**NSLPP MEETING HELD ON 04/06/2025****Attachments:**

ADDRESS/WARD: 93 Kurraba Road, Kurraba Point**APPLICATION NO:** DA128/24 (PAN-442850)

PROPOSAL: Demolition of the existing residential flat buildings, construction of a new residential flat building, excavation and construction of basement, new basement entry from Wallaringa Avenue and new landscaping.

OWNER: Kessef Pty Ltd**APPLICANT:** Gyde**AUTHOR:** Report of Michael Hornery, Executive Assessment Planner**DATE OF REPORT:** 18 May 2025**DATE LODGED:** 27 June 2024**DATE AMENDED:** 20 March 2025**RECOMMENDATION:** Approval

Figure 10: Height plane diagram showing the arse of the proposed building that exceed the maximum building height.

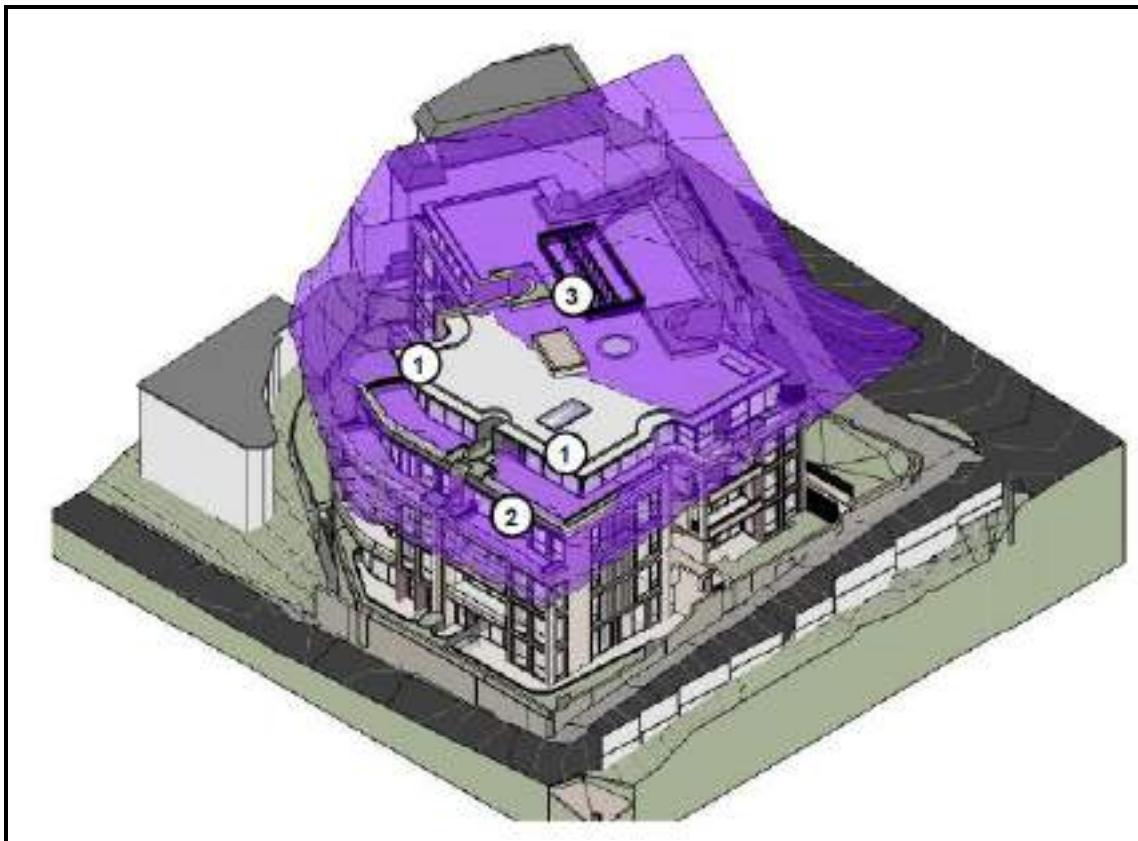
The location and extent of the non-compliance is provided in the height plan diagram below:

The proposed development seeks a variation to the development standard relating to height (Clause 4.3). The NSLEP identifies a maximum building height control of 12m. The building is proposed to be 14.76m in height to the parapet at roof level which exceeds the maximum building height by 2.76m, a variation of 23% to the development standard. The other portions of the building that exceed the maximum building height include the balustrade at level 3, being 12.27m and the screen around the AC which is 12.56m.

Figure 15 –Site area calculation plan showing the proposed site coverage, unbuilt upon area and landscaped area.

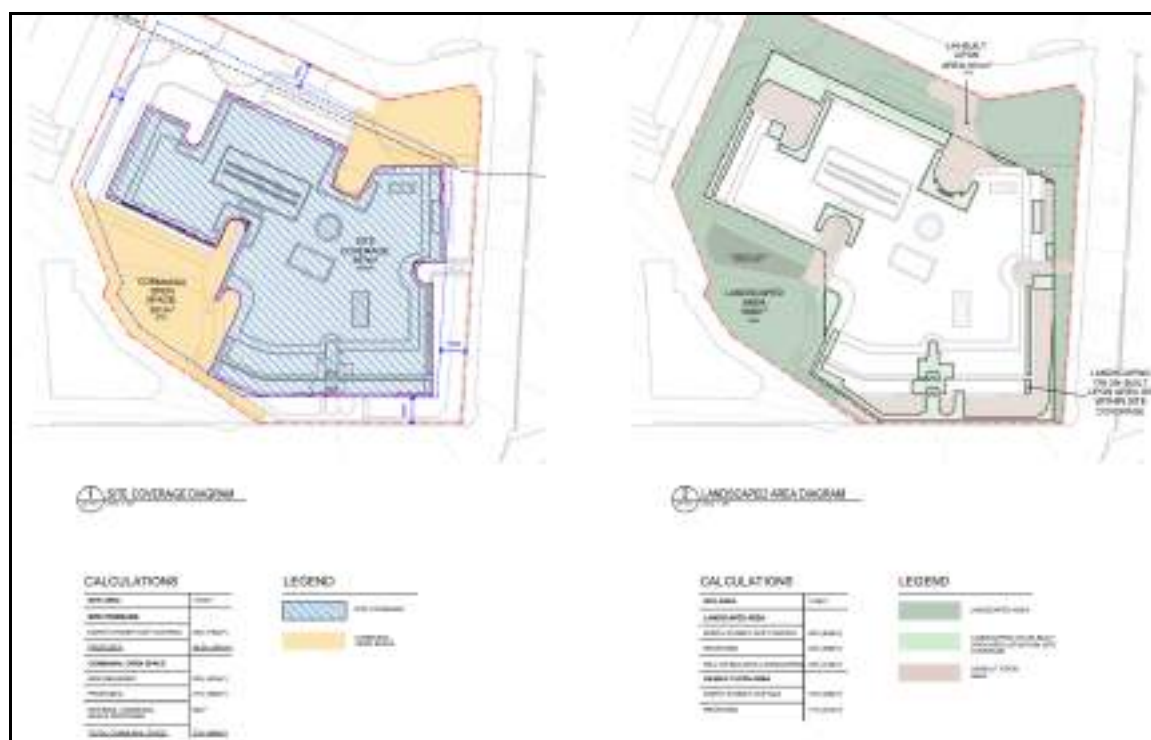
P6 Parking areas must be designed to enable cars to enter and leave the site in a forward direction.	Yes	Have been designed accordingly.
P7 Driveway and pedestrian access must be separated.	Yes	
1.5.5 Site Coverage	No, however acceptable on merit	The proposed development is subject to a maximum site coverage of 45% (779.85m ²). The site coverage of the existing buildings is currently 640m ² (36.9%) A site coverage calculation diagram is submitted as part of the architectural plans confirming the proposed site coverage at 847m ² (48.9%).

The applicant has provided the following in support of the variations to the site coverage, landscaped and unbuilt upon areas:

Figure 2 - Height plane diagram illustrating the variations of the height control and the locations referred to in Table 1.

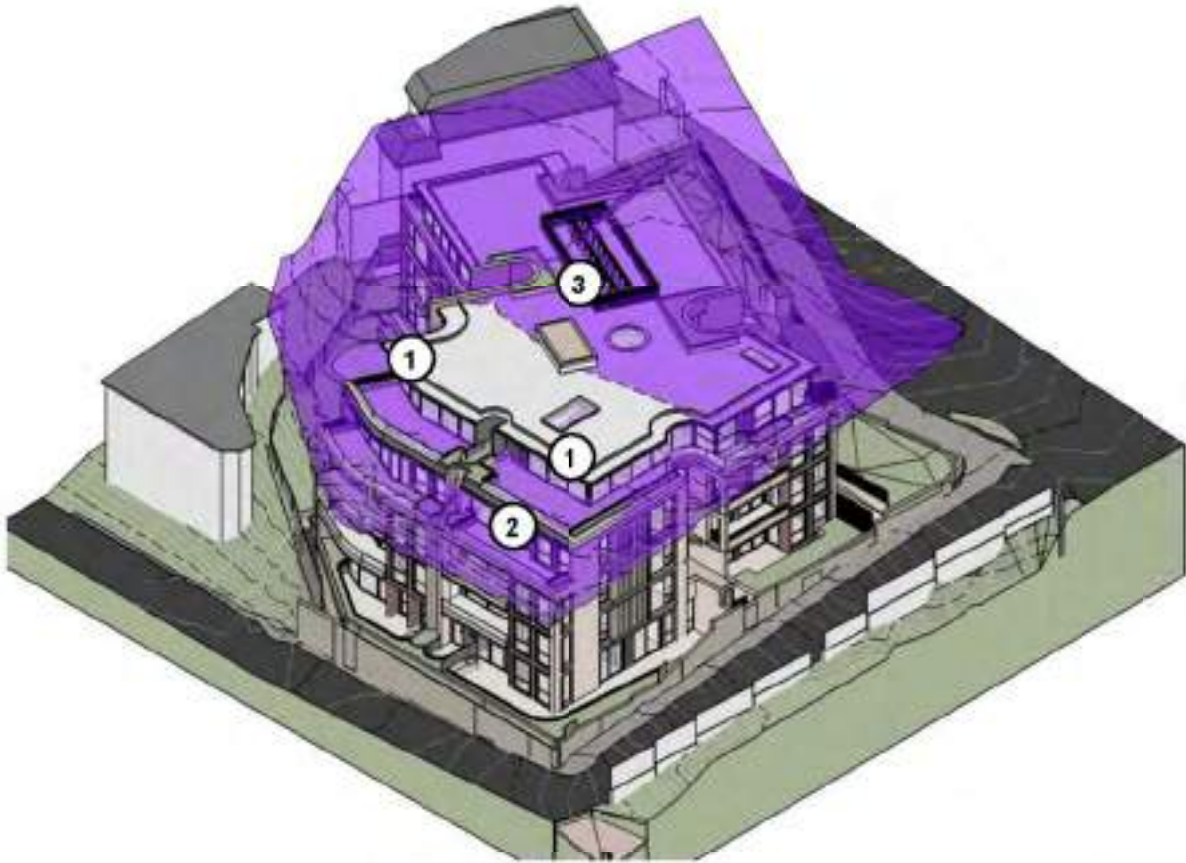
The following table identifies the 'building height' at different places on the building according to the 'extant' ground level (determined from the survey) immediately below each place.. These are the parapet on the roof of the building, the top of the balustrade on level 3 of the building and the top of the screen around the proposed air conditioning condensers on the roof of the building. They are identified in Figure 2 below.

Item	Description	Proposed RL	Existing ground level	Resulting building height	Extent of variation
1	Parapet at roof level.	RL 40.30	RL 25.54	14.76m	2.76m / 23%
2	Balustrade at L3	RL 37.54	RL 25.27	12.27m	0.27m / 2.2%
3	Screen around AC	RL 41.22	RL 28.66	12.56m	0.56m / 4.7%
